# REVIEW COMMENTS

FILE # SPR-95-75

TITLE HEADING: Site Plan Review -  
Warehouse Expansion

LOCATION: 2455 Industrial Blvd.

SITE PLAN  
DRAINAGE PLAN

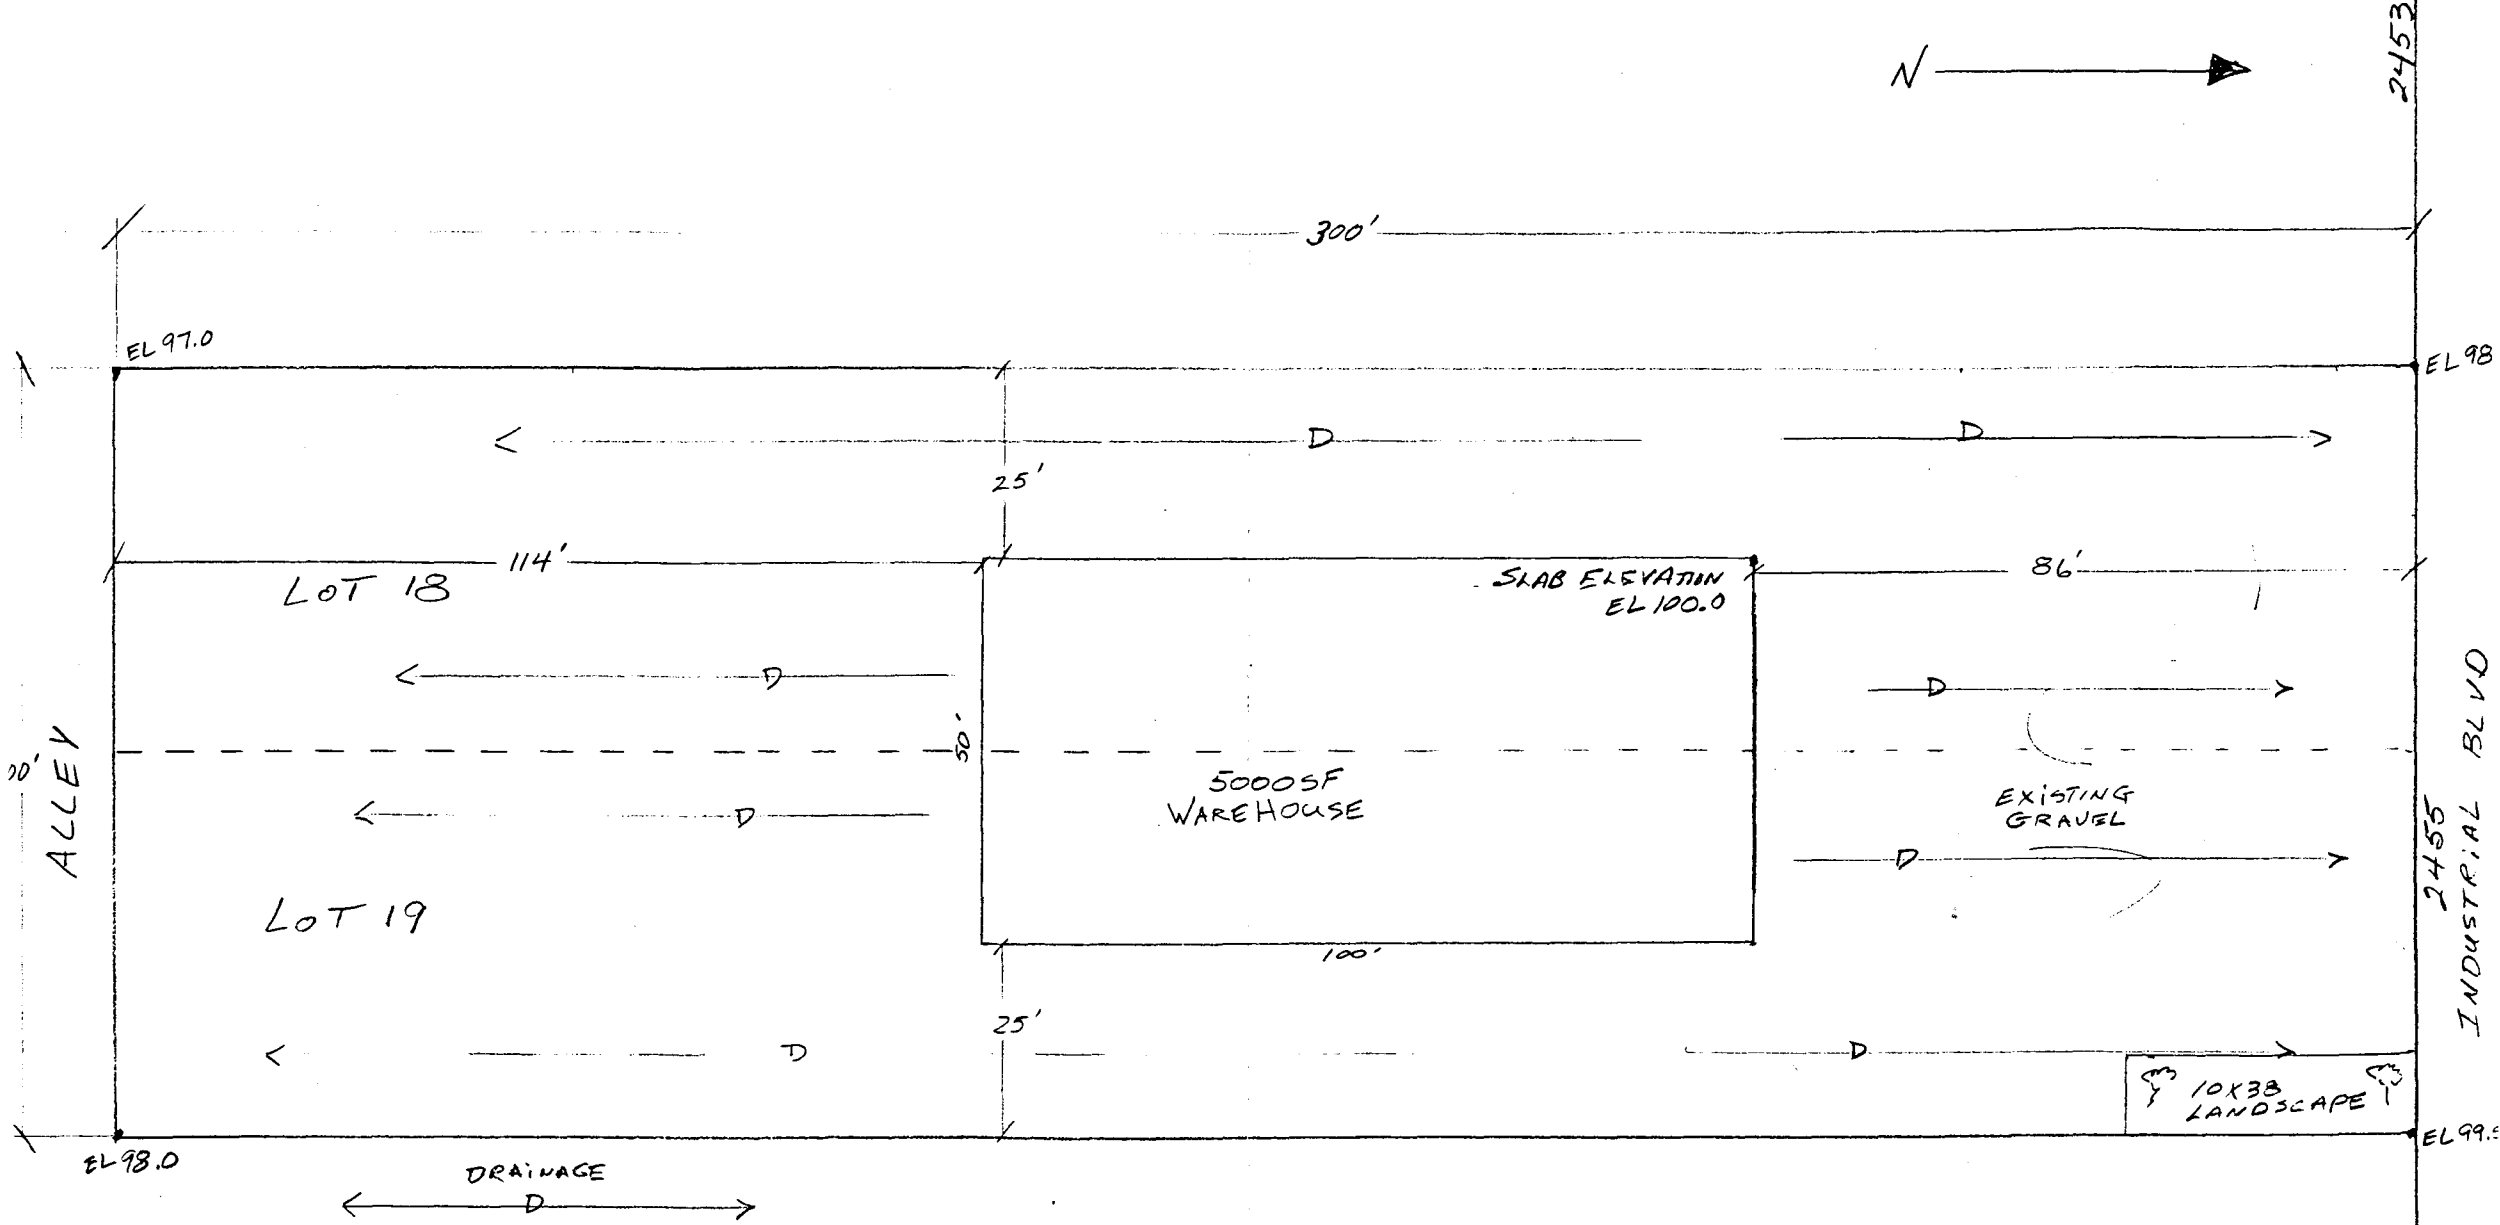
The attached site plan fails to show the route of the surface runoff to any natural watercourse. There is no way to tell if the northeast corner is even close to the same elevation as the existing adjoining lot.

Landscaped area required is  $100 \times 5 \times .75 = 375$  sq. ft.; 380 is proposed.

The tree to be provided must be at least 6' tall if an evergreen and 1 1/2" caliper measured 1' above ground level if deciduous. Please indicate on the plan the type and size of tree to be planted.

Of the required 375 sq. ft. of landscaped area, 150 sq. ft must be in shrubs. Please indicate the type and spacing of shrubs to be provided.

The landscaped area must be defined with raised curbing or railroad ties (or a similar method).
